SOLAR ENERGY CORPORATION OF INDIA LTD. NEW DELHI

SECI/C&P/SPD/RfS/Leh-Kargil/7500MW/122018/Amendment-1 dated Amendment-01 to the RfS for Selection of Solar Power Developers for Setting up of

dated 30.04.2019

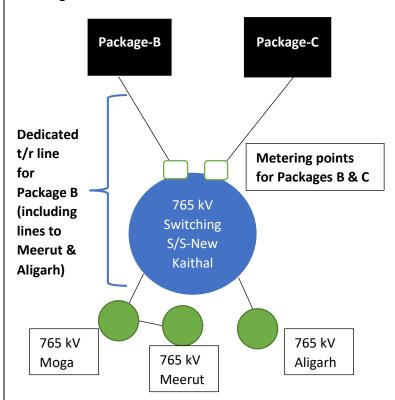
57.	Section-	Amended as follows:	2 7 7 2 7	
	VIII: Cl. C.1	7 and add as follows:		
		 The scope of the SPD shall include imp	olementation of the power evacuation and	
		transmission infrastructure upto the Delivery Point.		
		Package A: Delivery Point/Metering Point/Interconnection Point as defined in the RfS, for		
		Package-A has been identified as the 400 kV side of the 400/220 kV ISTS S/S at New Wanpoh,		
		Anantnag, Jammu & Kashmir. The above line may emanate from Zangla, traversing through		
		Kargil, Alusteng (Srinagar), and terminating in New Wanpoh. This route would utilize existing		
		New Wanpoh-Kishenpur transmission corridor.		
		Package-B: Bidders may carefully note that for the purpose of constructing the dedicated		
		transmission line as per the existing CERC regulations, <u>delivery points for the Package B shall</u>		
		be 765 kV sub-stations at Aligarh, Meerut and Moga. However, the Metering Point for the

purpose of billing and as defined in the RfS, shall be the 765 kV switching station at New		
		Kaithal (in the vicinity of Kaithal), at 765 kV level.		
		The SPD setting up Package-B shall be responsible to develop the complete transmission		
		system up to the above identified delivery points at Aligarh, Meerut and Moga. The 5000		
		MW power coming from Leh either through DC or AC system shall be fed to 765kV switching		
		station at New Kaithal, which will further be transmitted to the delivery points i.e. Aligarh,		
		Meerut and Moga through the following transmission system:

• Establishment of 765kV switching station in vicinity of Kaithal (New Kaithal SW		
		station)		
		 LILO of 765kV Moga-Meerut S/c at New Kaithal Switching station 		
		LILO OF 703KV WIOSA WICCIAL 3/C ALIVEW KAILITAL SWILCHING STATION

- New Kaithal Switching station Aligarh 765kV D/c line along with 240M VAr switchable line reactor at both ckts at each end
- 2x24OMVAr bus reactor at Kaithal Switching station.

The diagram as follows illustrates above:

It is re-iterated that Metering Point for the purpose of energy accounting for Package B shall be the 765 kV New Kaithal Switching Station, at 765 kV level.
